ADDENDUM No. 1
UCSF Comprehensive Parnassus Heights Plan Environmental Impact Report
State Clearinghouse Number 2020010175

Proposed Minor Revision to the
PARNASSUS RESEARCH AND ACADEMIC BUILDING AND WEST CAMPUS SITE IMPROVEMENTS

September 5, 2023

Figure 1: PRAB and West Campus Site Improvements

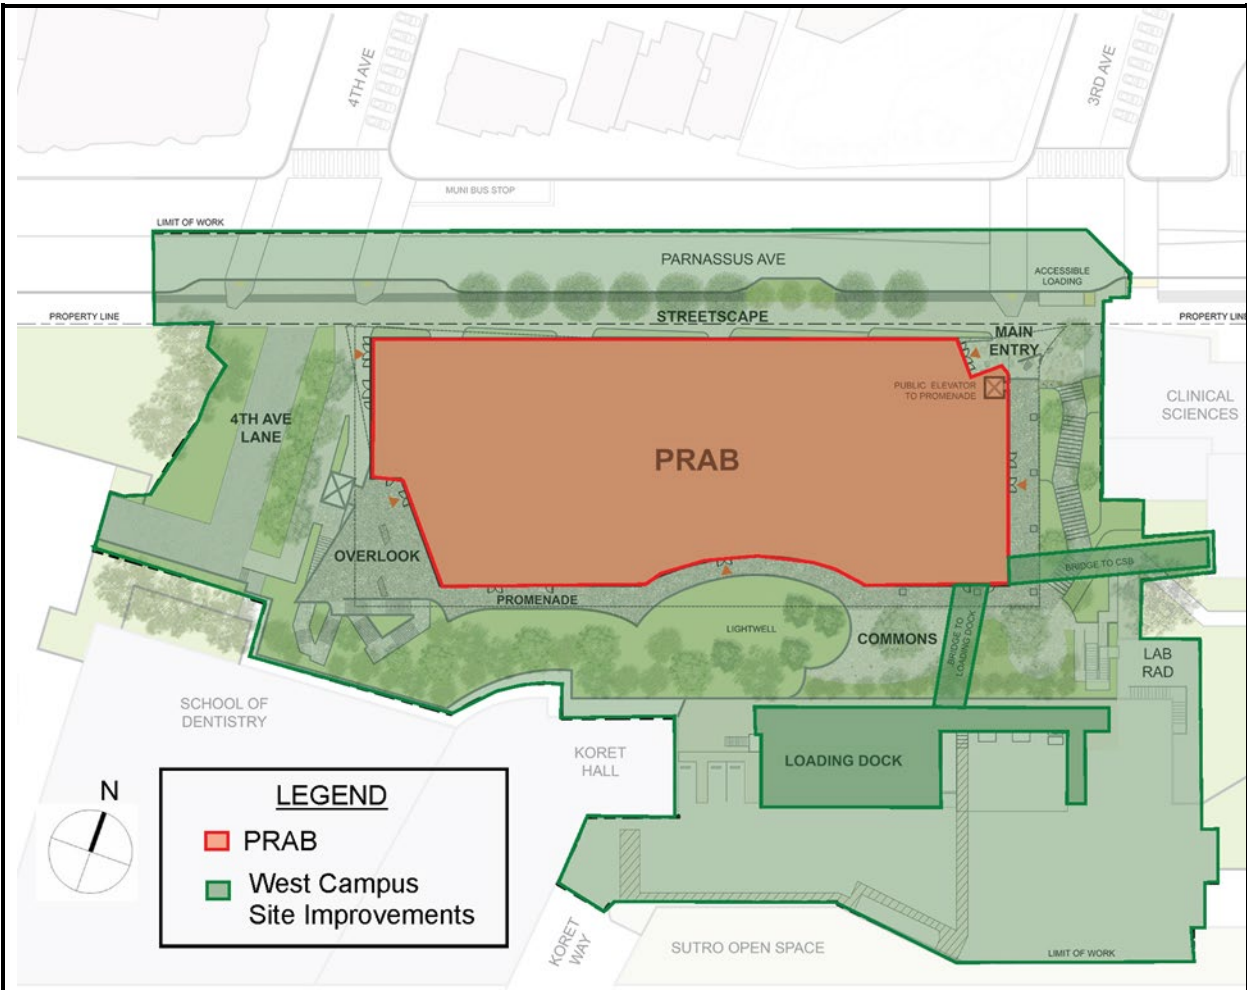
The revised PRAB involves the construction of an approximately 323,000 gsf building that would be nine stories and about 143 feet in height, excluding rooftop mechanical equipment. The project would also include a new free-standing loading dock in the rear of the new building with a bridge connecting the building to the loading dock, and another bridge connection to the adjacent Clinical Sciences Building. The associated West Campus site improvements would include a pedestrian promenade to the south, retaining walls in the rear of the site, infrastructure improvements, and landscaping. The extension of Fourth Avenue is not included in the project. The project elements are presented in **Figure 1**. The planned building and all associated West Campus site improvements are hereinafter called the PRAB project.

The project site is bounded by Parnassus Avenue on the north side, Faculty Alumni House on the west, Clinical Sciences Building on the east, and the Campus Support Services (former Laboratory of Radiobiology building) to the south. The project site includes a significant upward slope from the corner of 4th Avenue and Parnassus Avenue that involves a complicated hillside condition along the south and east elevations of the PRAB project site. The elevation changes from Parnassus Avenue to the rear of the planned building range from approximately 30 to 65 feet.
